UNITED STATES
DEPARTMENT OF THE INTERIOR
BUREAU OF LAND MANAGEMENTFORM APPROVED
OMB NO. 1004-0137
Expires: January 31, 2018**SUNDRY NOTICES AND REPORTS ON WELLS**
*Do not use this form for proposals to drill or to re-enter an abandoned well. Use form 3160-3 (APD) for such proposals.***SUBMIT IN TRIPLICATE - Other instructions on page 2**

5. Lease Serial No.
NMNM14768
6. If Indian, Allottee or Tribe Name
7. If Unit or CA/Agreement, Name and/or No.
NM061P3588C322
8. Well Name and No.
CERF FED COM 1
9. API Well No.
30-015-20830-00-S1
10. Field and Pool or Exploratory Area
BURTON FLAT
11. County or Parish, State
EDDY COUNTY, NM

**** BLM REVISED ** BLM REVISED ** BLM REVISED ** BLM REVISED ** BLM REVISED ****

PROPOSED WELLBORE

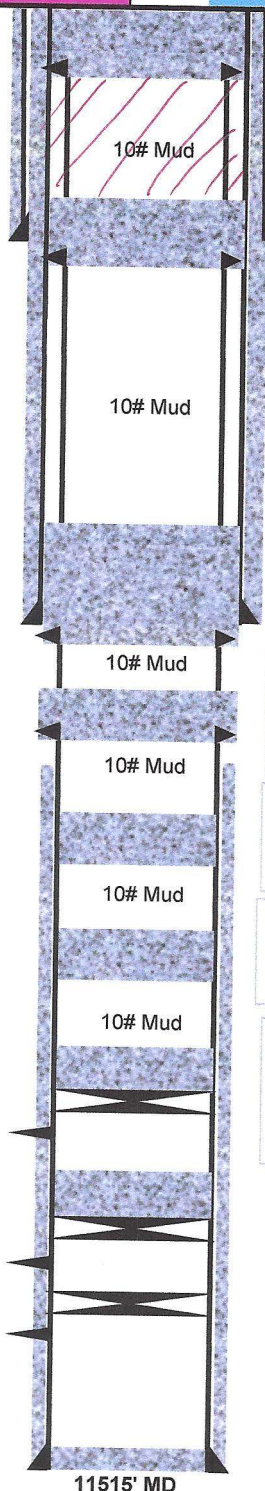
1. MIRU P&A unit. POOH production tubing from 9254'.
2. Set CIBP @ 9278'. Tag. Circ 10# salt gel. Spot 25 sx Cl H from 9278'-9078'. (Perfs at @ 9328') *Leak test CIBP*
3. Spot 25 sx Cl H from 8800'-8600'. (T. Wolfcamp @ 8735') *45 sx*
4. Spot 25 sx Cl C from 7250'-7000'. (Spacer)
5. Perf @ 5185'. Sqz 25 sx Cl C from 5185'-5075'. (T. Bone Spring @ 5132') *45 sx (5185'-5030') (In/out) (WOC/TAG)*
6. Perf @ 3050'. Sqz 150 sx Cl C from 3050'-2600'. WOC & tag. (Shoe @ 2992'; T. Delaware @ 2664') *(3050'-2587')*
7. Perf @ 650'. Sqz 55 sx Cl C from 650'-490'. WOC & tag. (Shoe @ 599'; T. Yates @ 545') *650'-surface, 195 sx*
8. Perf @ 140'. Sqz Cl C in/out from 140' to surface.
9. Cut wellhead off 3' BGL. Set dry hole marker. *Verify @ surface (In/out)*

Capitan, High Cave

Verify @ surface.
(In/out)
